Los Alamos County

PLANNING & ZONING COMMISSION STAFF REPORT

Public Hearing Date: February 26, 2020
Subject: Case No. SUB-2020-0010
Owners/Applicants: Bradley Parker; William D. Parker; Lorri Lynn McInroy; Debora A. Holmes
Case Manager: Desirae J. Lujan, Associate Planner

A request for approval of a subdivision Sketch Plan to divide a 11.62-acre lot into 49-residential lots. The vacant property, Ponderosa Estates Lot CTC A, addressed as 285 MAPLE DR, is zoned Planned-Development 2.0 (PD-2).

Exhibit A: 2020 Ponderosa Estates, Phase 3 Sketch Plan

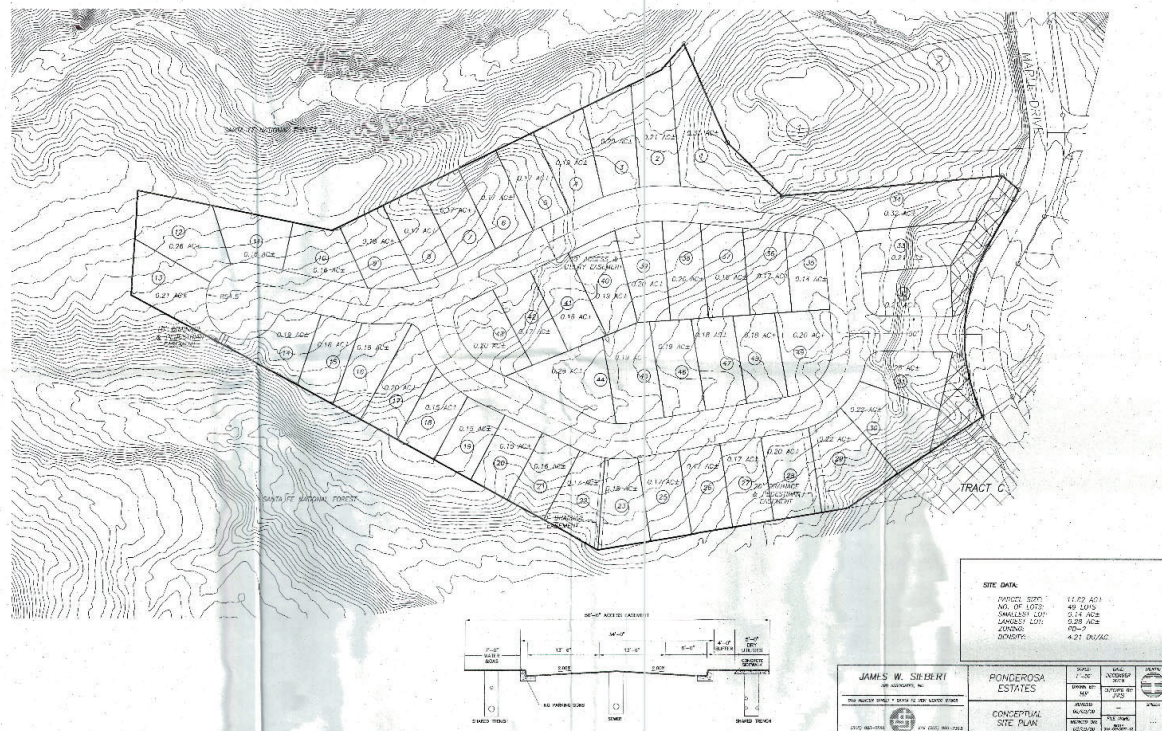
1. *The 50 ft. road right-of-way proposed is in accordance with the Public Works Design and Construction Standards for local road dedication to County.*
 - a. *Please note, a section of Maple Drive that includes the proposed Phase 3 intersection has not been dedicated and accepted by the County. In order to ensure continuousness road right-of-way to the development site and continuity of associated county service and maintenance, the proper drainage analysis, drainage and road infrastructure for this section of Maple Drive shall be provided as part of the development proposal.*

-
2. *The road cross section proposed appears to be consistent with the previous phases of the Ponderosa Estates Subdivision. Consistency with previous phase is acceptable, but note the following:*
 - a. *Recommend the sidewalk continue around the cul-de-sac and connect the sidewalk at the adjacent intersection to provide a continuous pedestrian loop.*
 - b. *Pedestrian curb ramps shall be installed on the west and east sides of Maple Drive at the intersection of the access to the development site for ADA compliance.*

- a. *Concur with pedestrian easements for access to established recreational trails and open space or as recommended by the Community Services/Parks, Rec. and Open Spaces Division.*
- b. *Drainage easements proposed may require adjustment pending completion of the drainage analysis.*
- c. *Utility easements as recommended by DPU.*

4. *Proposed roadway and drainage infrastructure and analysis shall be in accordance with Public Works Design and Construction Standards unless otherwise noted and/or approved by the County Engineer. Concur with the applicant's response to Subdivision Review Criteria D regarding storm water drainage shown below:*

-
1. *Question: If/When the subdivision is built, will the streets become county-owned?*
 2. *In lieu of the surface drainage easements, place drop inlets and storm drainage pipes to outlet locations.*
 3. *Roadway drainage on the north side of the loop cannot be determine without contour labels.*

-
1. *The subdivision should ensure adequate space for a refuse truck to access the site and turn around.*
-

1. *Replace J1 with 200A Coffin Box: PJB2-4, Junction Loop Subdivision.*
 2. *Transformer placement and size will depend on home load calculations.*
 3. *Recommends Civil/Engineer coordination for sewer connection/location with DPU early in the design process.*
 4. *Off-site gas improvements may be required.*
 5. *10' public utility easement on each side of the Access Easement.*
-

The applicant has been made aware of the IDRC outcome and is working to include the requests into a Preliminary/Final Plat submittal.
